## **VILLAGE OF CALEDONIA UTILITY DISTRICT MEETING AGENDA**

**RE:** O'Malley Investments – 4526 Northwestern Avenue – Storm Water  
Management Plan & Grading Plan for Land Disturbance Permit Conditional  
Approval

**RE:** Prairie Pathways Phase IV Utility & Grading Plan Conditional Approval

The Caledonia Utility District and the Village of Caledonia have performed a review of the Subdivision Plan sheets for the proposed Button Bush Drive expansion (Phase IV) in Prairie Pathways. The Engineering Improvement Plan is dated October 18, 2021 and was received on October 19, 2021. Below is a summary of the review comments.

2019.0131.01  
SHEET  
C-8

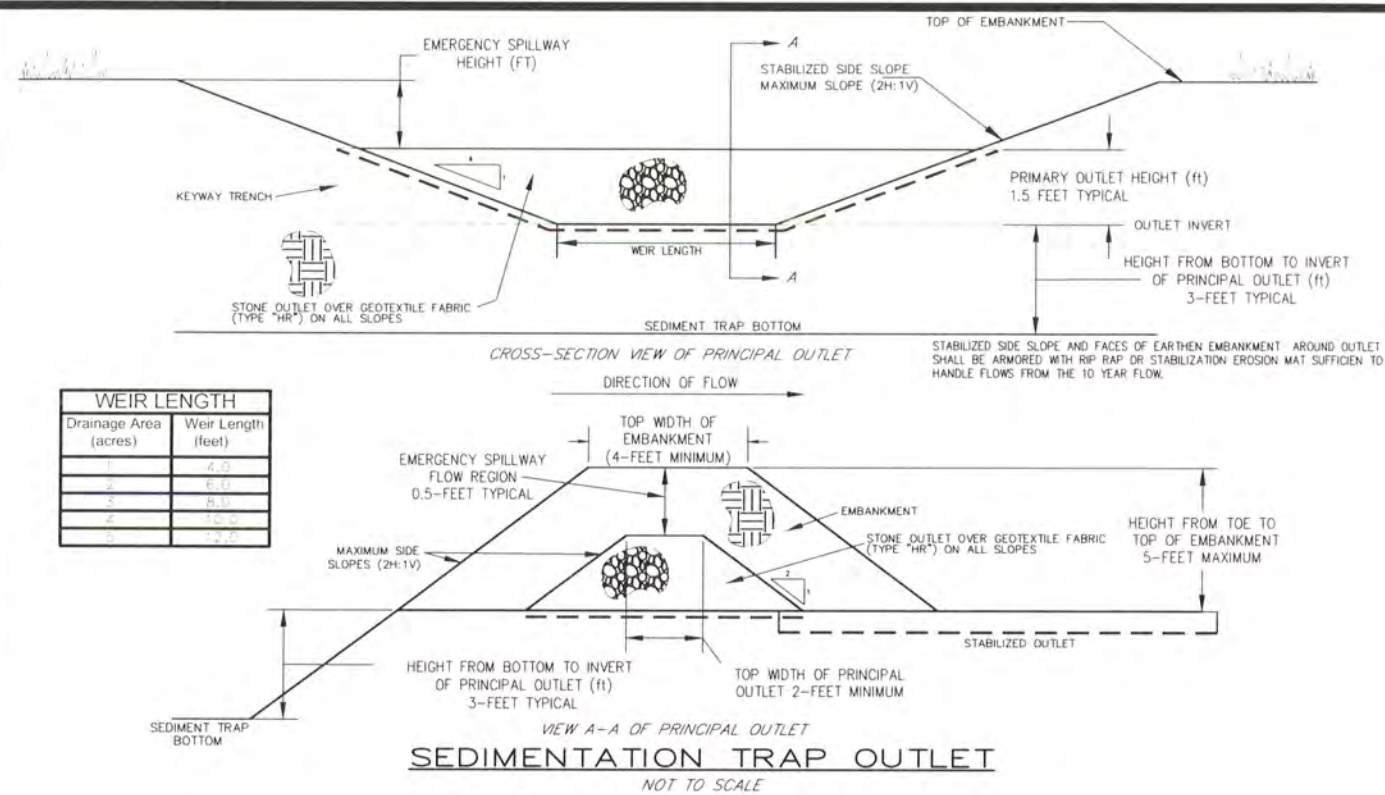
- Provide a copy of the WDNR WRAPP (NOI).
- Complete a Village of Mount Pleasant Storm Water Permit.
- Obtain WisDOT access Permits as necessary.
- Adjust the 100-year High water elevation on the pond profile (Sheet C-8).

MASTER GRADING PLAN

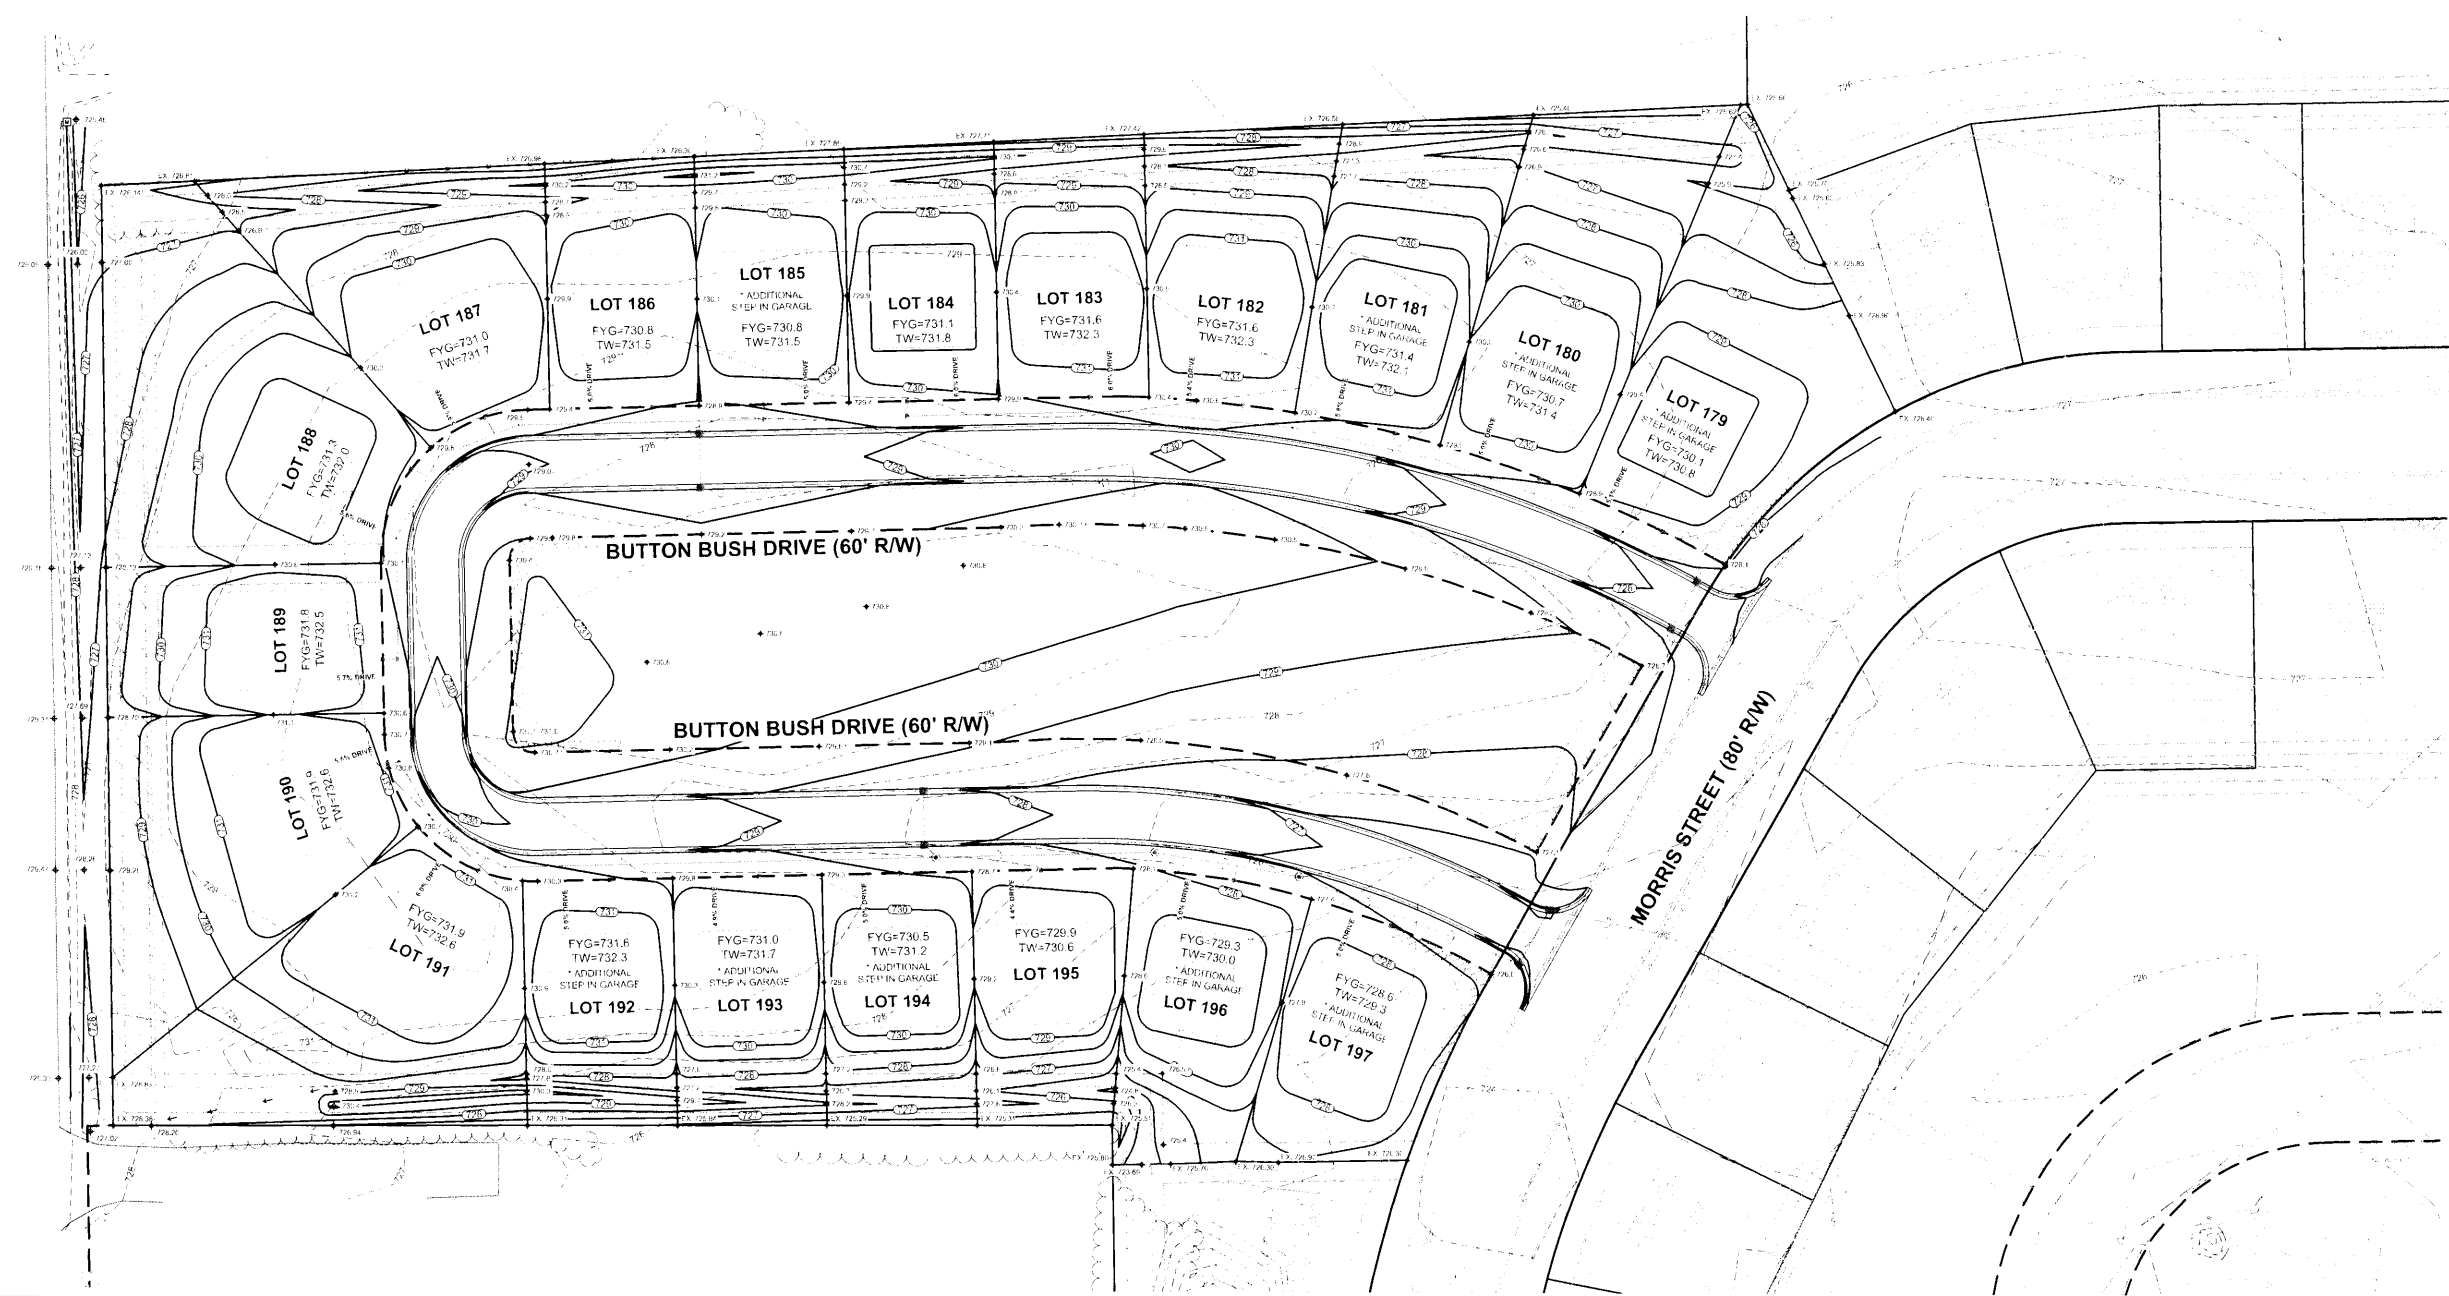
- **Grading Plan**
  - Rear Yard Swale for Lots 191-196. What is currently proposed moves the swale outside of the easement. What is recommended is that the rear yard swale centerline be centered in the Drainage Easement. Recommend coming out of the Storm Sewer in the rear yard of 196 and have the swale at 0.8%. Then create a 1.5' berm in the rear 12' to contain the

- Correct the Typo on the contour in the Right of Way of Highway H behind Lot 189.
- Rear Yard Swale on Lot 179, 183 & 185 do not have the minimum centerline slope of 0.8%.

**WATER MAIN PLAN &  
PROFILE**

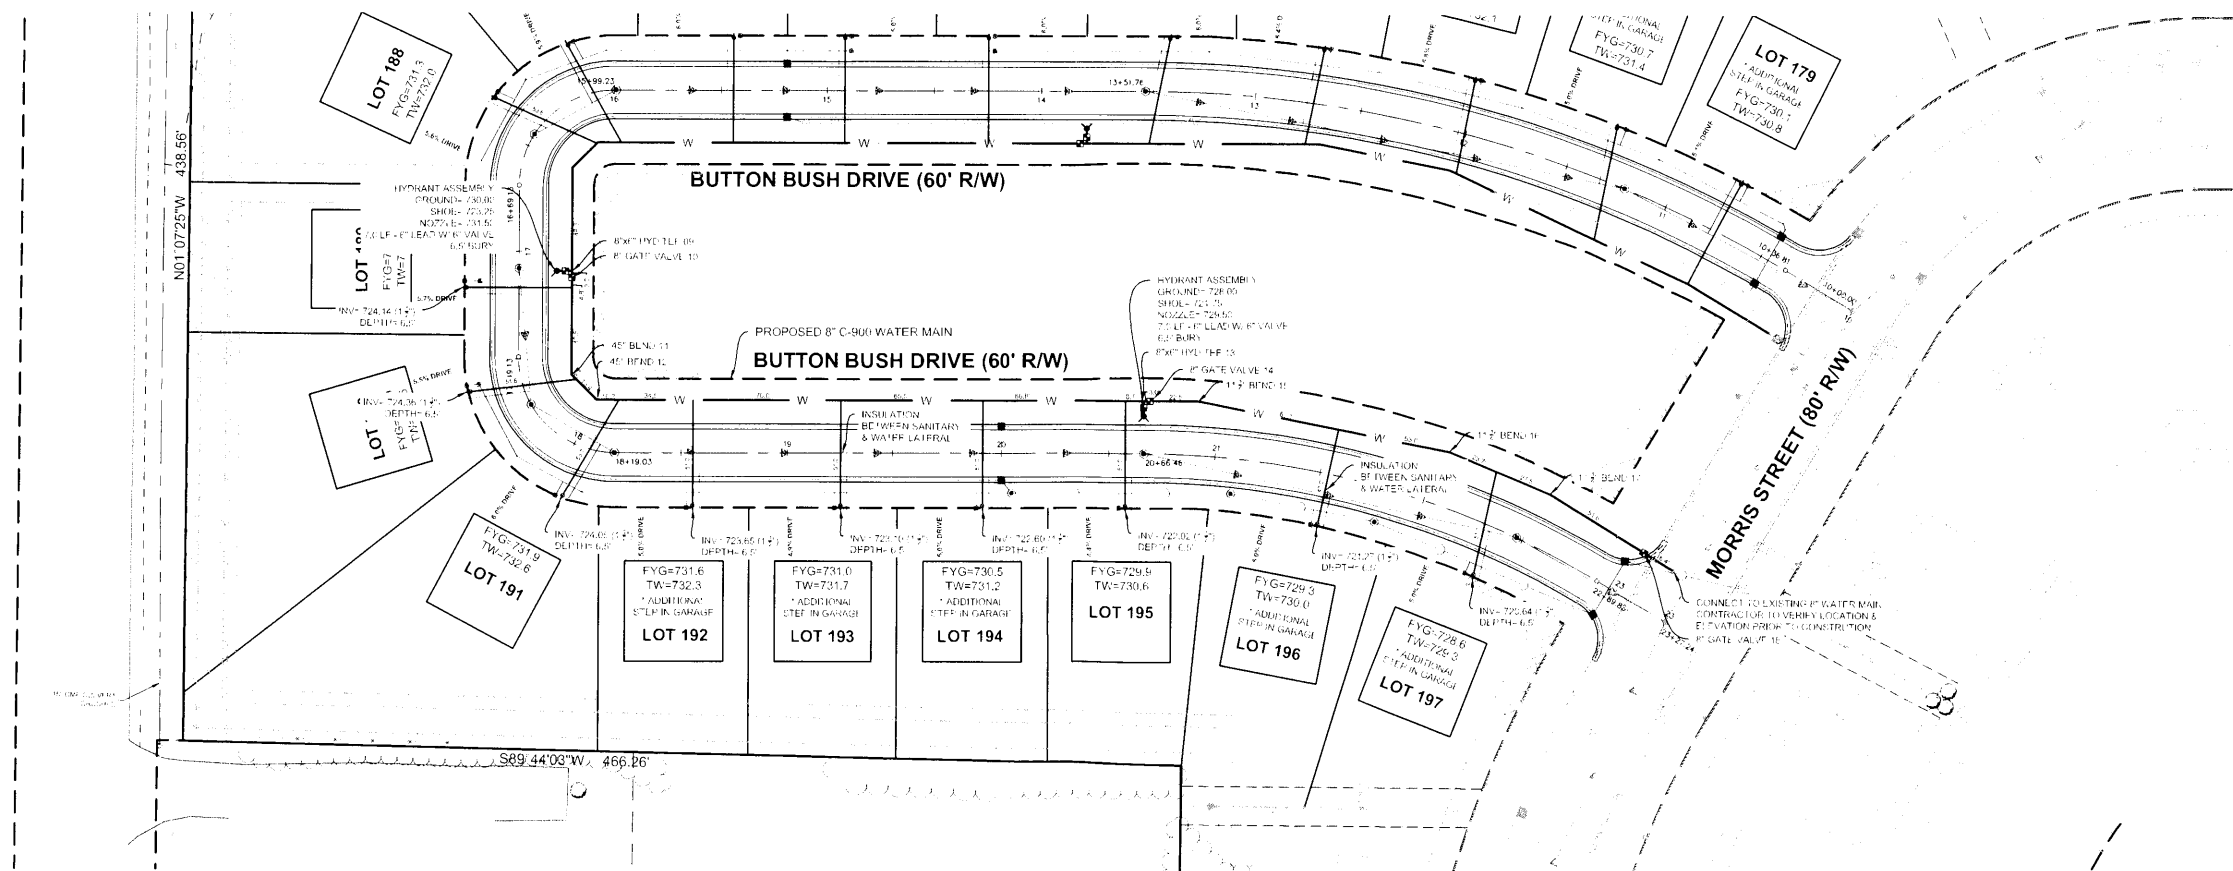
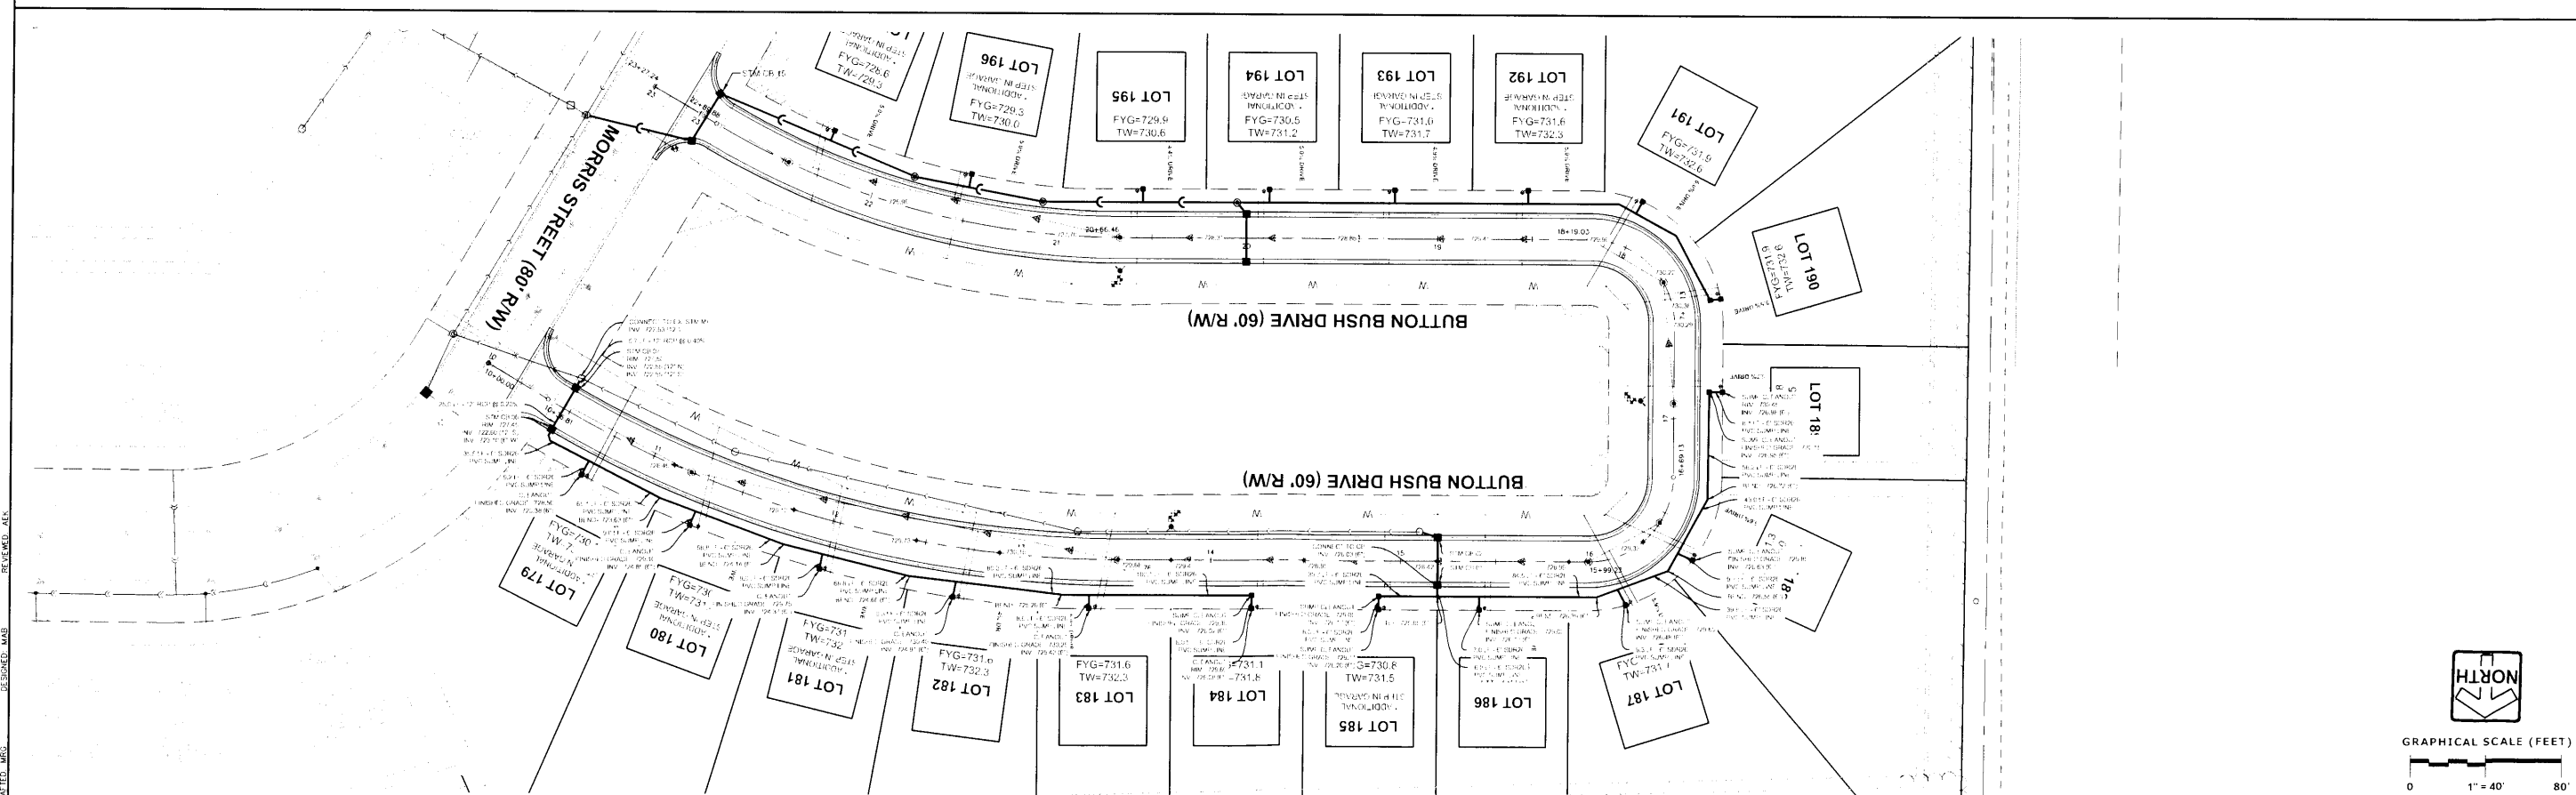
- Watermain
  - The watermain and sanitary sewer are close in elevation from STA 17+00 to 23+25. They added two notes to the plan view on Sheet 8 regarding the insulation you requested. I would recommend they make that note say "(TYP)" for all water services shown on Sheet 8 of 13.
